AGENDA
HAILEY PLANNING & ZONING COMMISSION
Monday, August 17, 2020
Virtual Meeting
5:30 p.m.

PH 1 Consideration of a Design Review Application by Leonard McIntosh and Edward Aub-Trustee for a twelve (12) unit residential project, two stories in height, to be known as River Street Apartments. The proposed project will be located at 410 North River Street(Lots 14-17, Block 56, Hailey Townsite), within the Business (B),Townsite Overlay (TO) Zoning Districts and the Downtown Residential Overlay (DRO) and Small Residential Overlay (SRO); however, the Applicant has chosen to meet the DRO Standards, as outlined in the Hailey Municipal Code. The proposal also includes: twelve (12) parking spaces, four (4) four-bedroom ADA accessible units, four (4) two-bedroom ADA accessible units and four (4) four-bedroom units. **ACTION ITEM.**

STAFF REPORT
Hailey Planning and Zoning Commission
Regular Meeting of August 17, 2020

A1 SITE PLAN
SCALE: 1" = 10'-0"

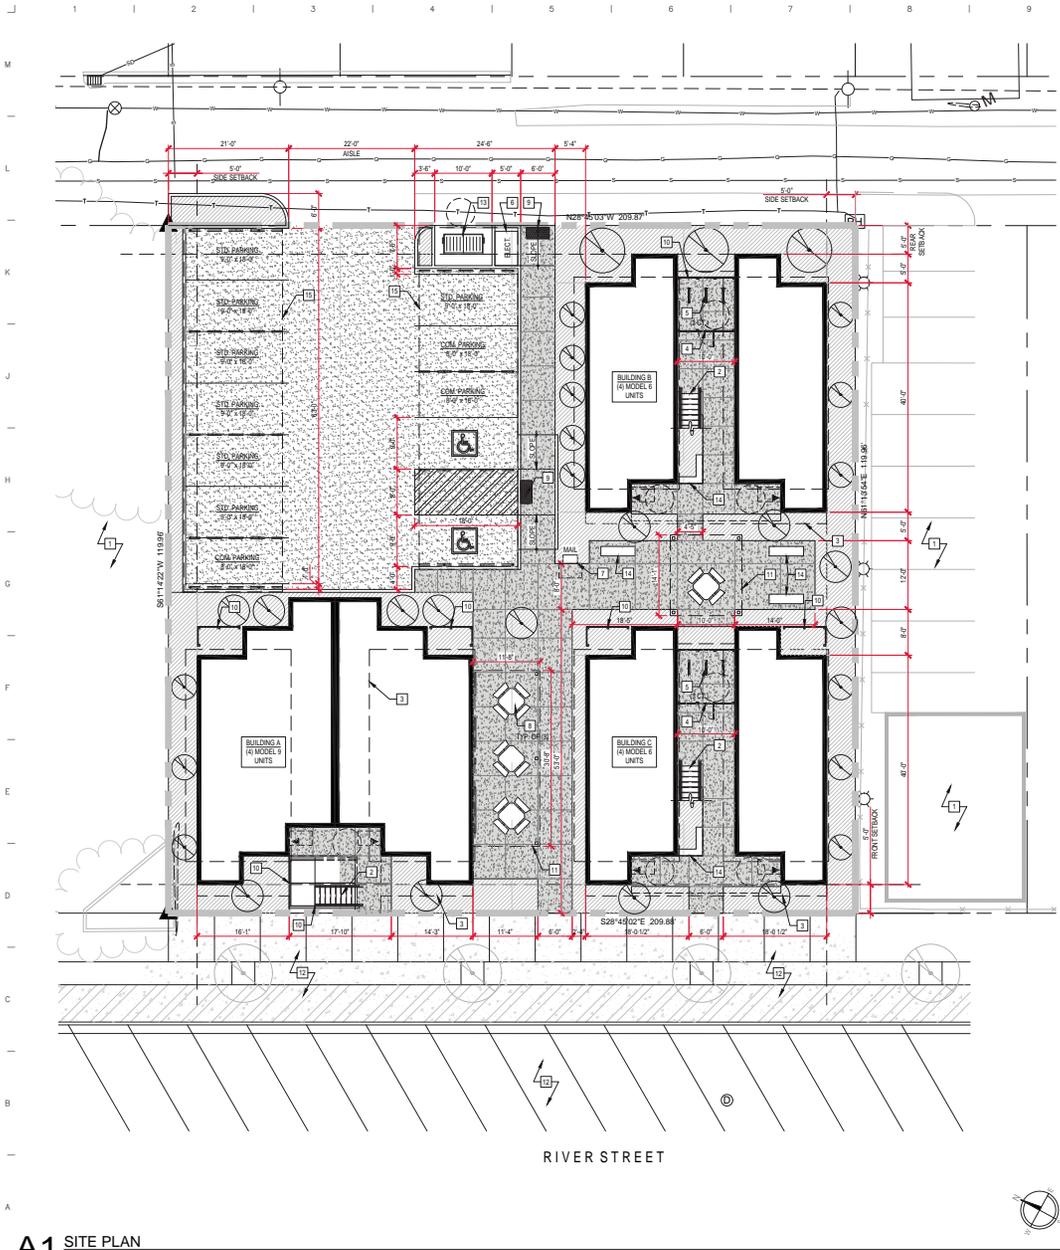
The proposed Site Plan shows a building with twelve (12) onsite parking spaces, of which, two (2) spaces are accessible spaces and three (3) spaces are compact spaces. All onsite parking is proposed to be covered.

The Site Plan also incorporates public right-of-way improvements, which count toward the required guest parking spaces outlined in the Downtown Residential Overlay standards.

L-1

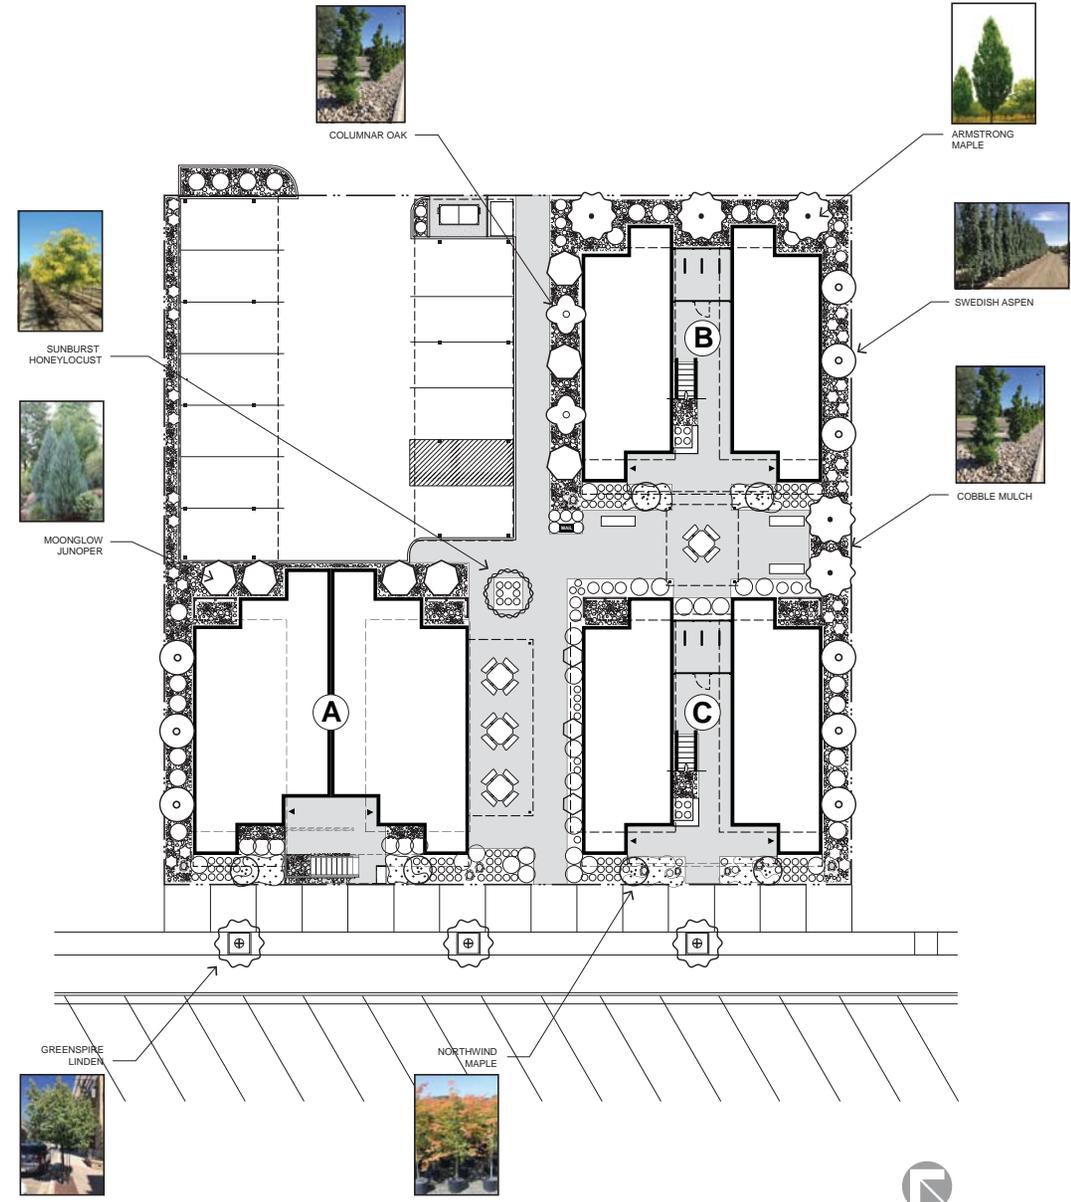
A preliminary Landscape Plan has been provided, which includes various drought-tolerant trees, shrubs, ground covers and grasses, listed below, and inert materials, such as cobble mulch, concrete walkways, bench seating, picnic tables and boulders.

That said, the Commission may wish to discuss the preliminary Landscape Plan and offer suggestions regarding planting type, size and location.

G1 BUILDING A - FRONT ELEVATION
SCALE: N.T.S.

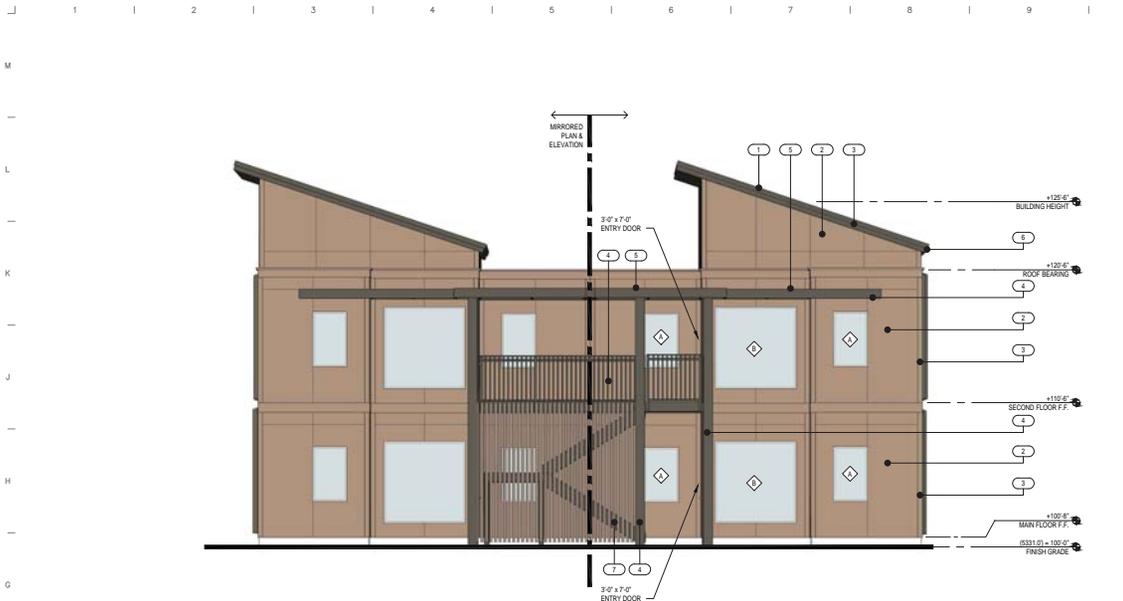
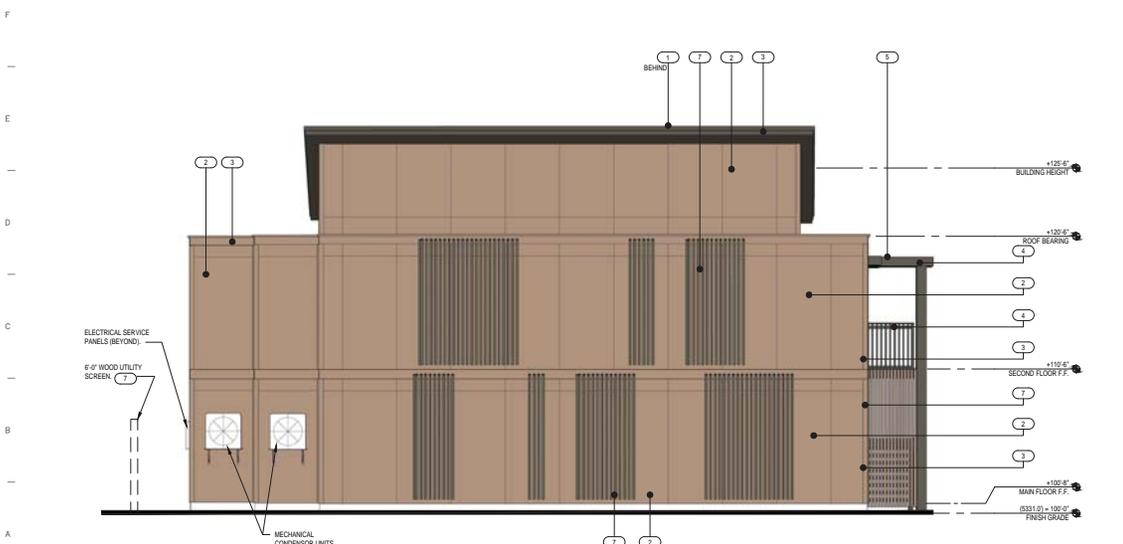
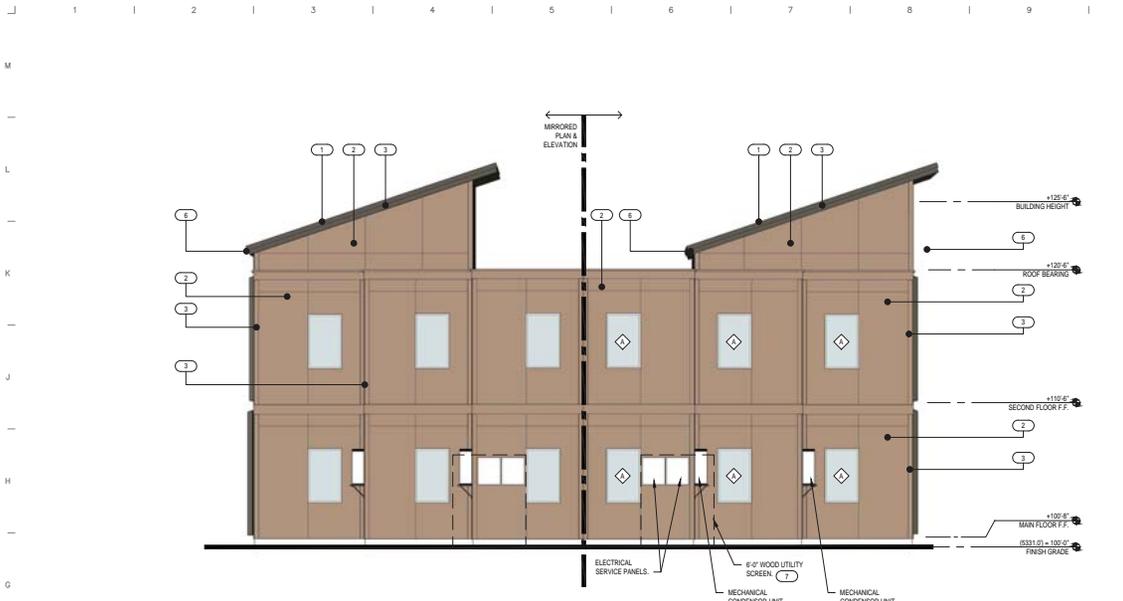
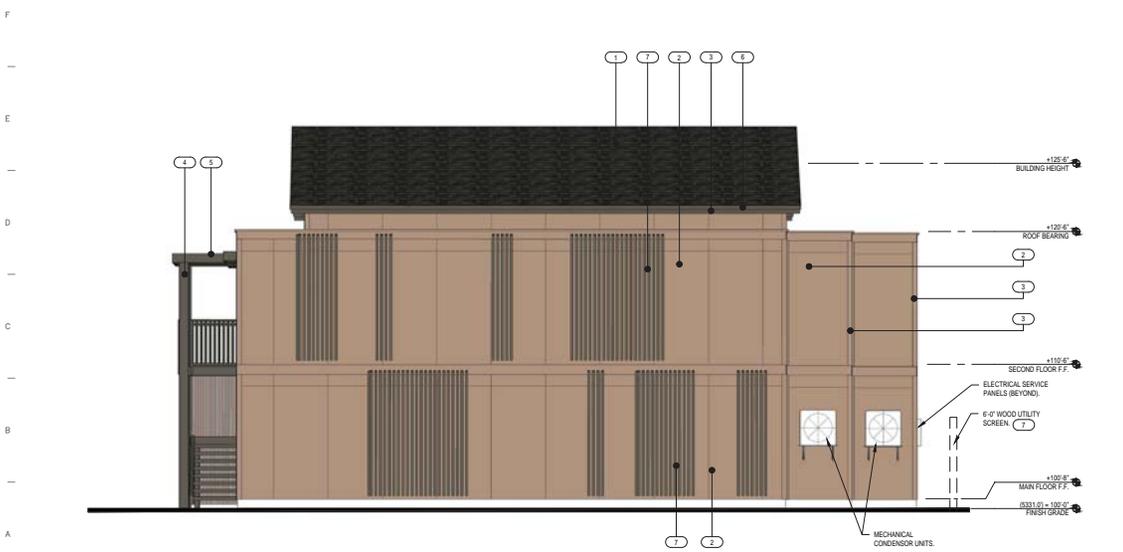
1. **Building Design:** The Commission may wish to discuss the overall building design, which contains a long wall along River Street. Undulation is created by the utilization of balconies and breezeways. The buildings see shed roofs to provide further interest.
